# Access Compliance Report

## Public Rights-of-Way

### (Pedestrian Signals)

Intersection ID: N/A	Main Street:	Cross Street: N/A	Location: N/A
ADA ID: 6DE438F0762B	Signal Type: One Push Button-Non APS	Overall Compliance: No	Severity Score: BTN 1: N/A BTN 2: N/A No BTN: N/A
Codes/Mitigation Info/Possible Solution		Field Measurements/Component Compliance

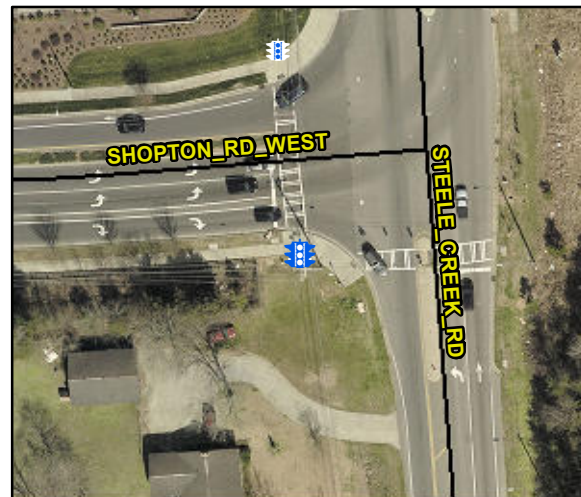
PROW/ADA: TMUTCD 4e.08, R406.2, R404.7.3

Yes	B 1 Clear Xing Direction?	ClearlyMarked	N/A	B 2 Clear Xing Direction?	N/A
	B 1 Crossing Direction	To N		B 2 Crossing Direction	N/A
Yes	B 1 DistanceTo XWalk (in)	0.0	N/A	B 2 DistanceTo XWalk (in)	N/A
No	B 1 DistanceTo Curb (in)	162.0	N/A	B 2 DistanceTo Curb (in)	N/A
Yes	B 1 Diameter (in)	2.0	N/A	B 2 Diameter (in)	N/A

Possible Solutions: Replace Signal Push Button With APS Button on New Post. Remove & Relocate Sign.
